A d d e n d u m

Iowa Department of Transportation
Office of Contracts

B.O.	Proposal ID	Proposal Work Type	County	Project Number	Addendum
103	07-0636-078	PCC PAVEMENT- GRADE & REPLACE	BLACK HAWK	NHSX-063-6(78)--3H-07 NHSX-063-6(91)--3H-07 NHSN-063-6(95)--2R-07	20DEC103A08

Summary of change the plans to the follow following plan sheets: NHSX-063-6(78)--3H-07

NORTH PUMP STATION - TOP PLAN

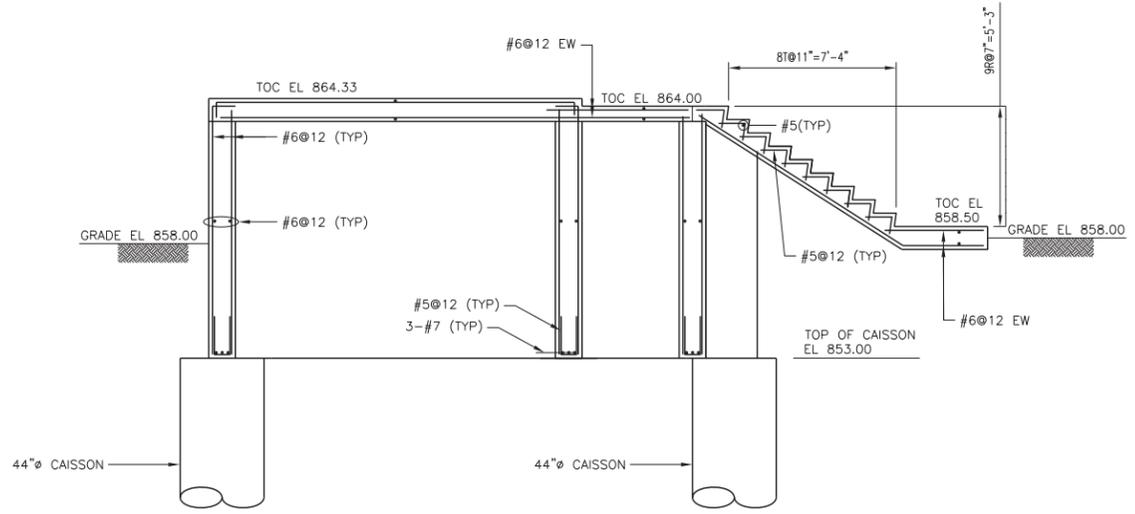
Sheet M.208	Plan Sheet Change	Revised dimension and showed aluminum grating.
Sheet M.209	Plan Sheet Change	Added note concerning caisson installation and testing under "Section A".

NORTH PUMP STATION - PROCESS PIPING

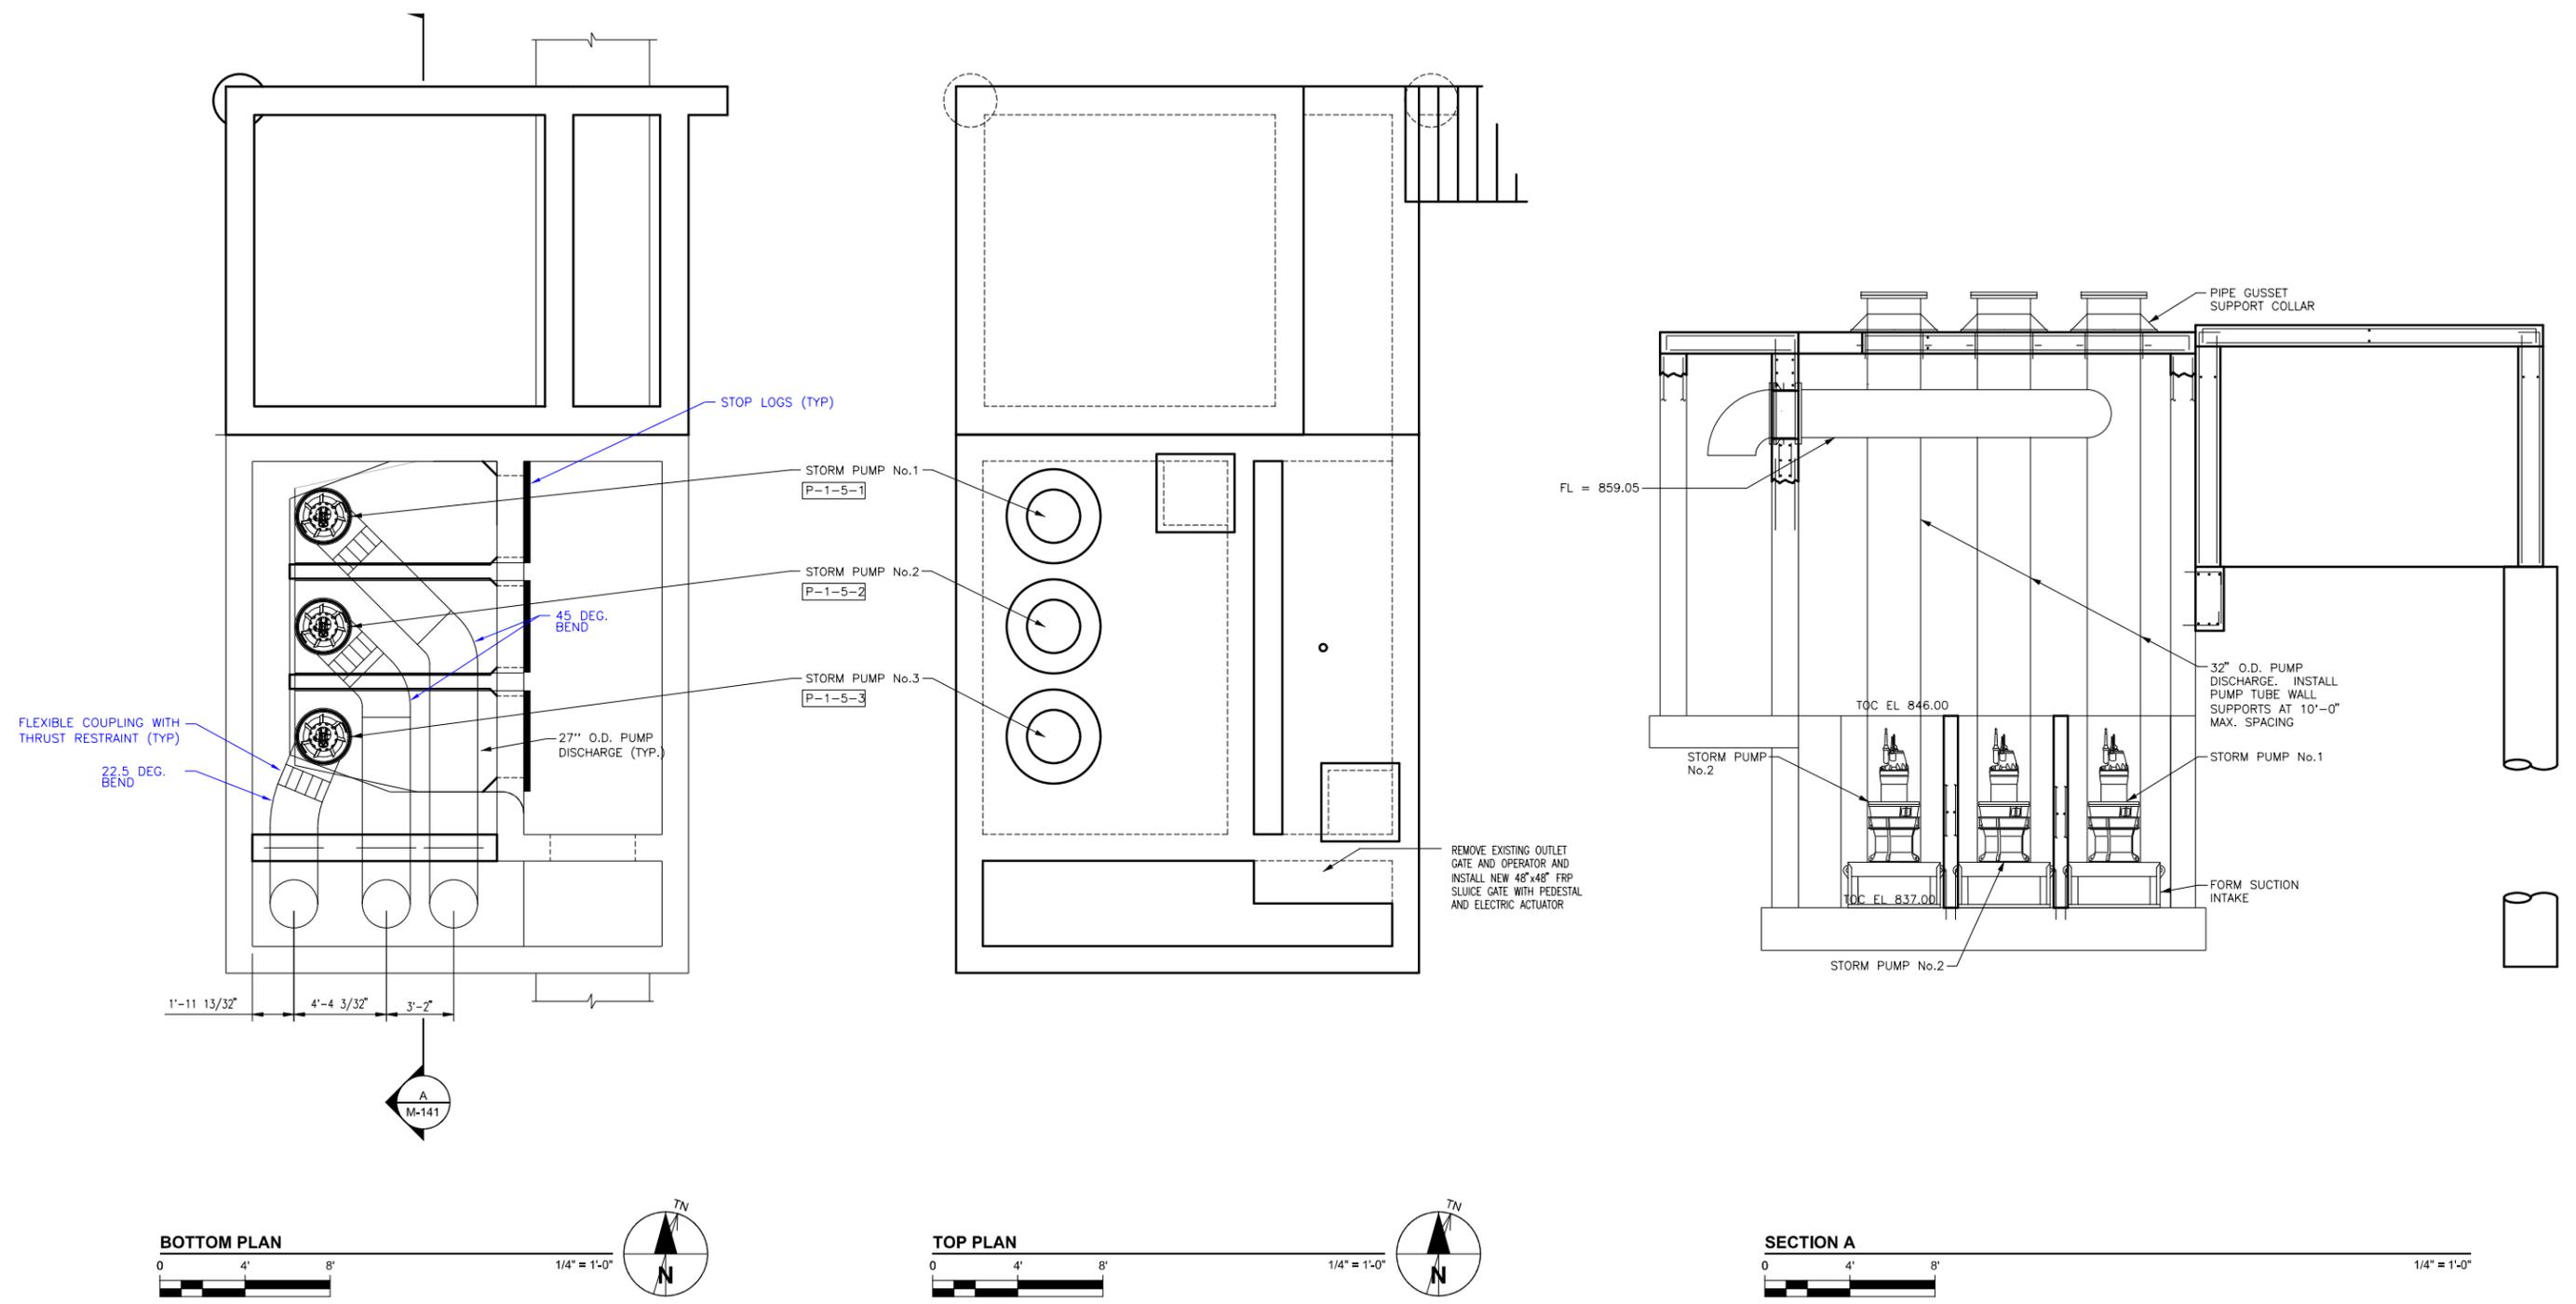
Sheet M.212	Plan Sheet Change	Added information on stop log height under “Bottom Plan”, added note about removal and replacement of outlet gate on “Top Plan” and added note about discharge pipe size and wall supports on “Section A”.

NOTE:
 CHANNELS FOR STOP LOGS SHALL BE SURFACE MOUNTED ON ENDS OF WALLS PER MANUFACTURER'S
 RECOMMENDATIONS. STOP LOGS TO EXTEND FROM EL 837.00 TO EL 846.00. EACH STOP LOG SHALL BE
 1'-0" IN HEIGHT

NORTH PUMP STATION - ELECTRICAL SERVICE PLANS

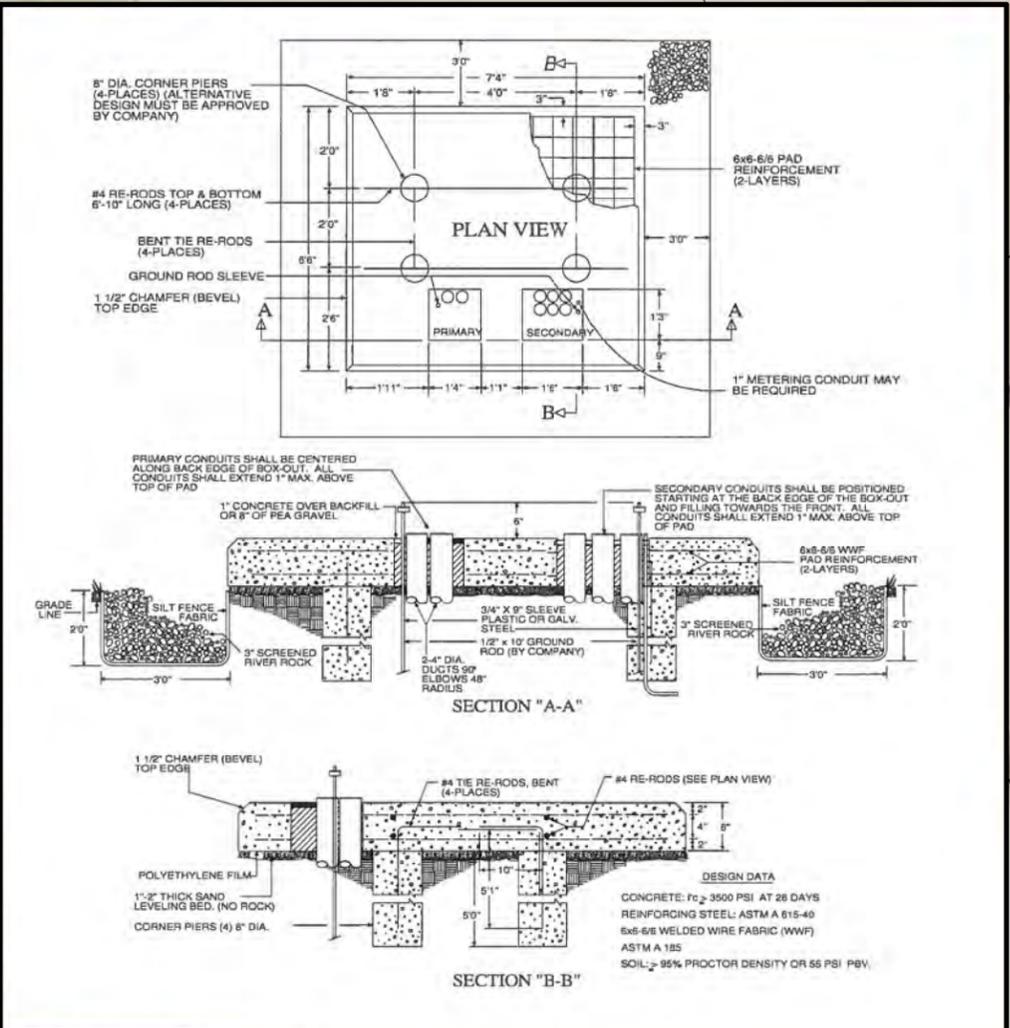
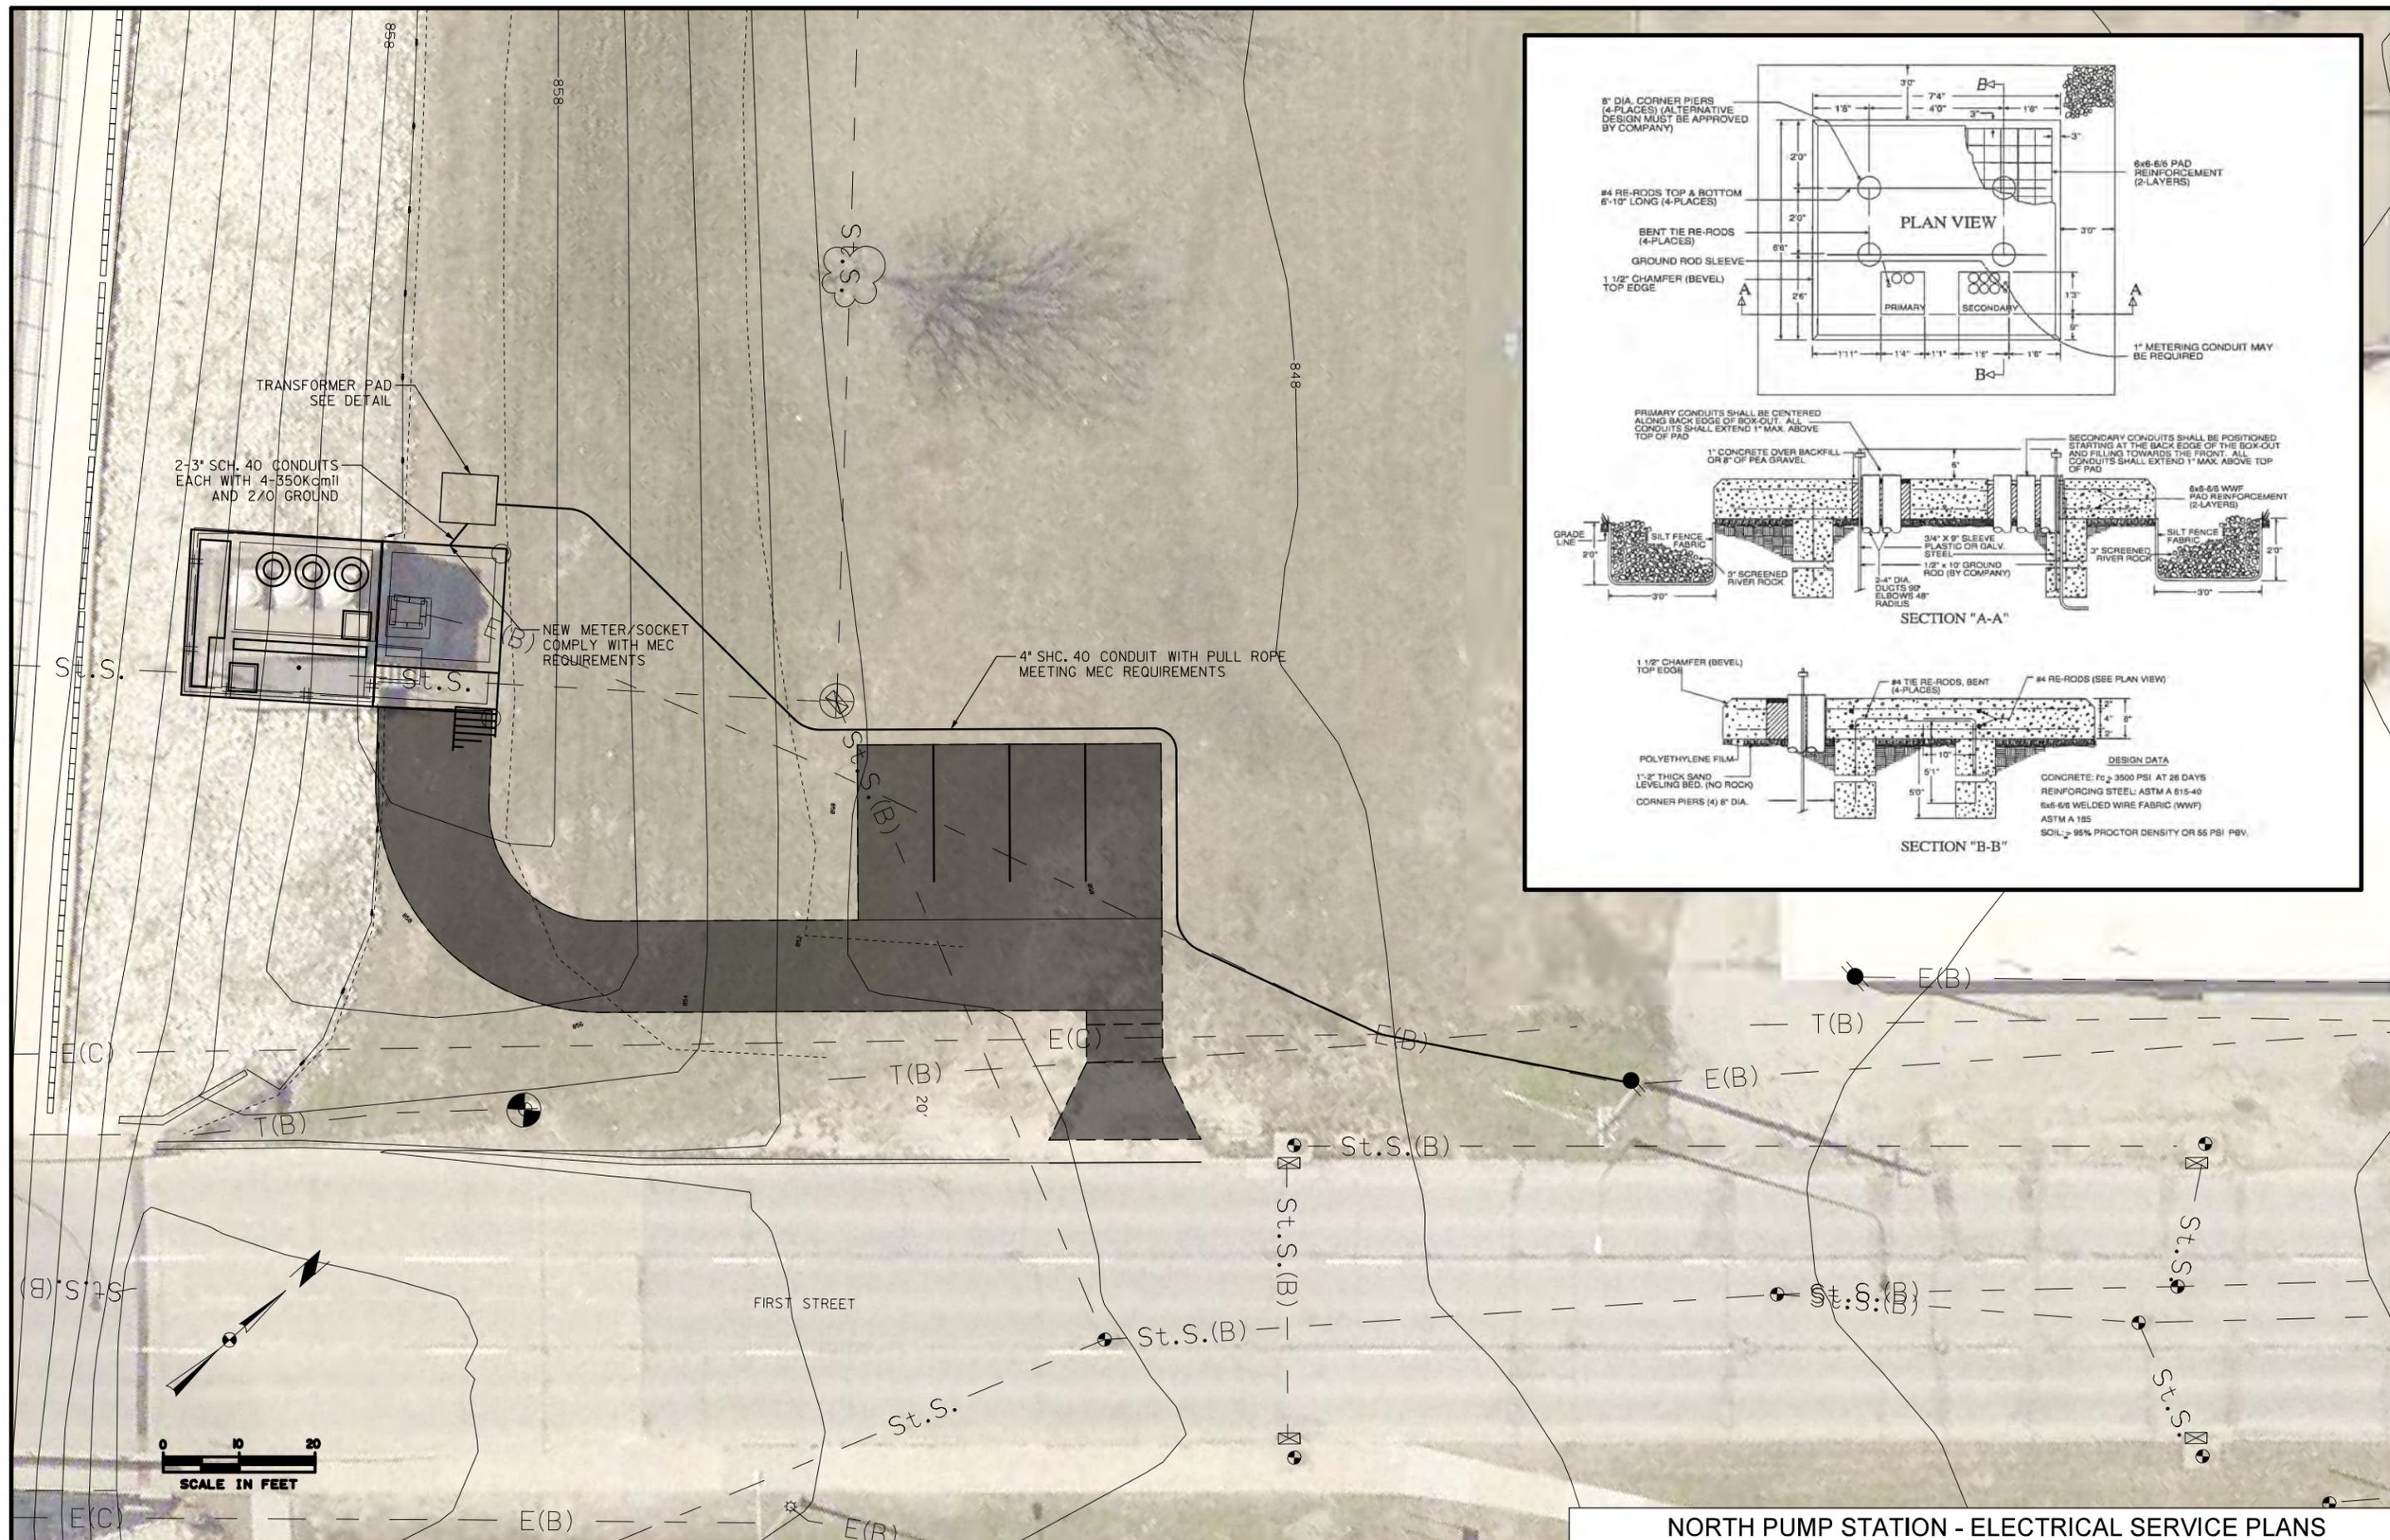
Sheet M.215A	Plan Sheet Addition	Added a new plan sheet showing the electrical service for the North Pump Station.
Sheet M.307	Plan Sheet Change	Revised waterstop note on “New RCB to New Concrete Structure” detail.

SOUTH PUMP STATION - BOTTOM PLAN

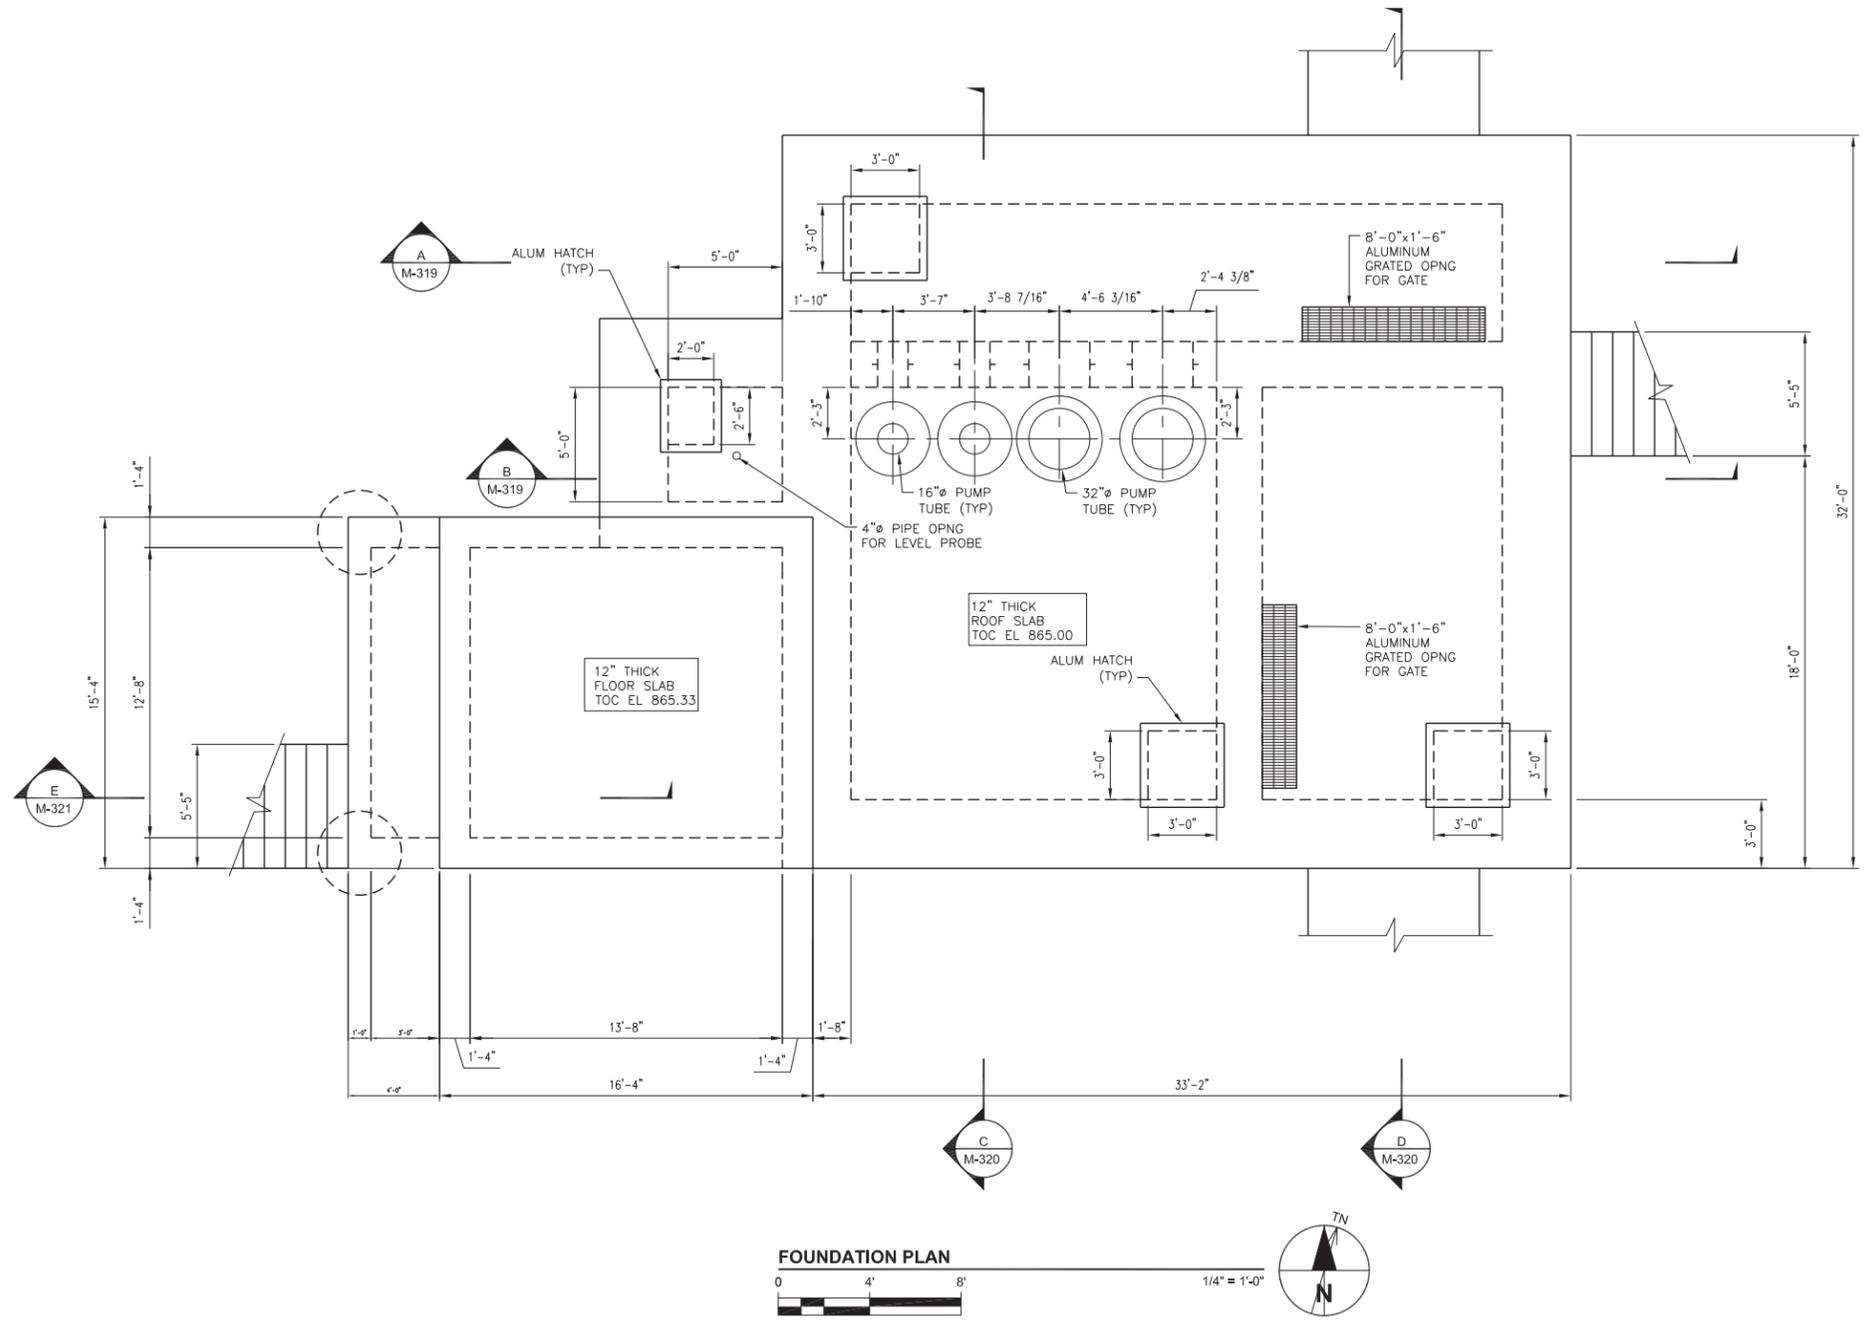
Sheet M.317	Plan Sheet Change	Added dimension for foundation overhang on “Foundation Plan”.
Sheet M.318	Plan Sheet Change	Showed Aluminum Grating in “Foundation Plan”.
